PRODUCT/ PROCESS CHANGE NOTICE

Number: 2007-1
Date: 9/03/20
ECO#: 11518, 11519
ECO Ref.: (Class: 3 Notification)

Products Affected: D75J-040.0M, DV75C-040.0M

Original configuration:

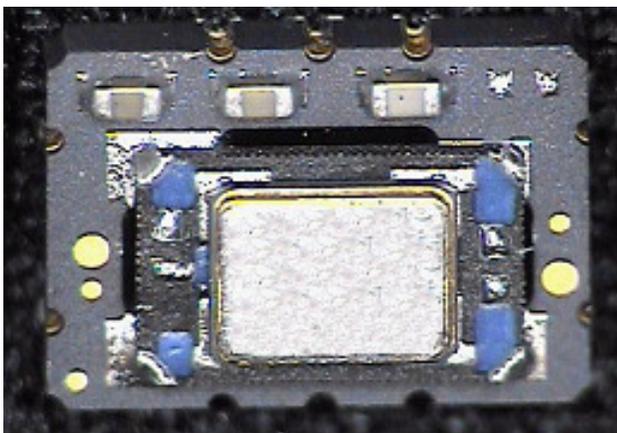
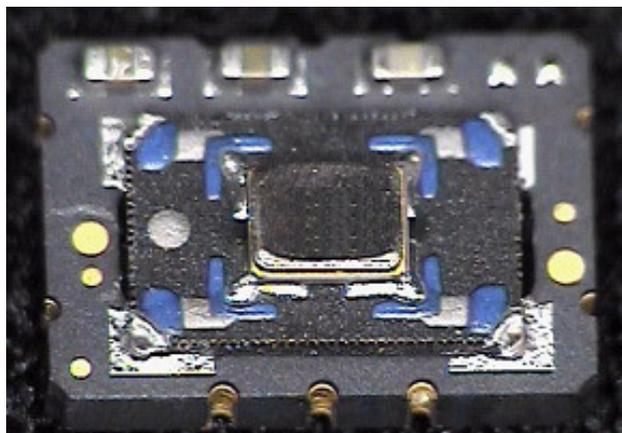
Change Description: 1) Component (quartz crystal) size change. 2) Modification of the ceramic adapter substrate to accommodate the smaller crystal footprint.

Marking example of the new configuration. The date code changes from YYWW format to YM date code format:

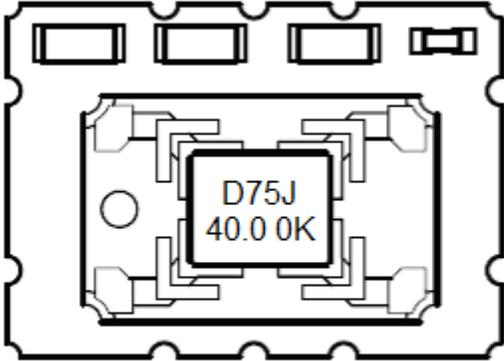
Effect on Product Performance: Electrical performance of the part does not change. Due to the smaller area available for part number and date code marking, the date code format will change from a 4-character (YYWW) format to a 2-character (YM) format.

LASER, 2 CHARACTER DATE CODE

Y = Year	M = MONTH
0 = 2020	A = JAN
1 = 2021	B = FEB
2 = 2022	C = MAR
3 = 2023	D = APR
	E = MAY
	F = JUN
	G = JUL
	H = AUG
	J = SEP
	K = OCT
	M = NOV
	N = DEC
